JH-7110 Errata Sheet

Doc ID: JH-7110-ESEN-001

This document mainly provides information about known device issues affecting StarFive SoC JH-7110.

Figure 1-1 GMAC 1,000 M Only

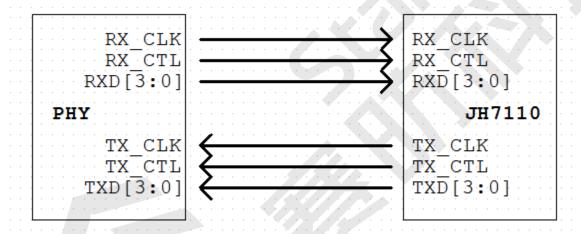
JH-7110 only supports RGMII mode for Ethernet GMAC connections.

If you only need to support 1,000 M mode, you can design the layout following the requirements below.

Layout requirements.

- The RX/TX trace length cannot exceed 6,000 mil.
- Match the RXD[3:0] signal group and the RX_CTL and RX_CLK signals with trace length to within 100 mil. Match the TXD[3:0] signal group and the TX_CTL and TX_CLK group trace length to within 100 mil.
- The routing of data and clock lanes should keep a complete reference plane.

Figure 1-2 GMAC 10 M/100 M/1,000 M Auto-Negotiation

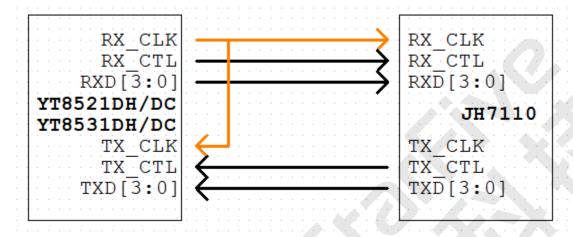
For auto-negotiation mode, only the following PHY models are supported.

- YT8521DH/DC
- YT8531DH/DC

Plus, you need to connect the RX_CLK of the PHY to its TX_CLK as shown by the orange lines in the following diagram.

Layout requirements for GMACO.

- The trace length from TX_CLK to RX_CLK cannot exceed 500 mil.
- The RX and TX trace length cannot exceed 4,300 mil.
- Match the RXD[3:0] signal group and the RX_CTL and RX_CLK signals with trace length to within 100 mil.
- Match the TXD[3:0] signal group and the TX_CTL and RX_CLK signals with trace length to within 100 mil.
- The routing of data and clock lanes should keep a complete reference plane.

Layout requirements for GMAC1.

- The trace length from TX_CLK to RX_CLK cannot exceed 500 mil.
- The RX_CLK trace length cannot exceed 4,000 mil. Match the RXD[3:0] signal group and the RX_CTL and RX_CLK signals with trace length to within 100 mil.
- The TX_CLK trace length is 2,000 mil longer than that of the RX_CLK. Match the TXD[3:0] signal group and the TX_CTL and RX_CLK signals with trace length to within 100 mil.
- The routing of data and clock lanes should keep a complete reference plane.
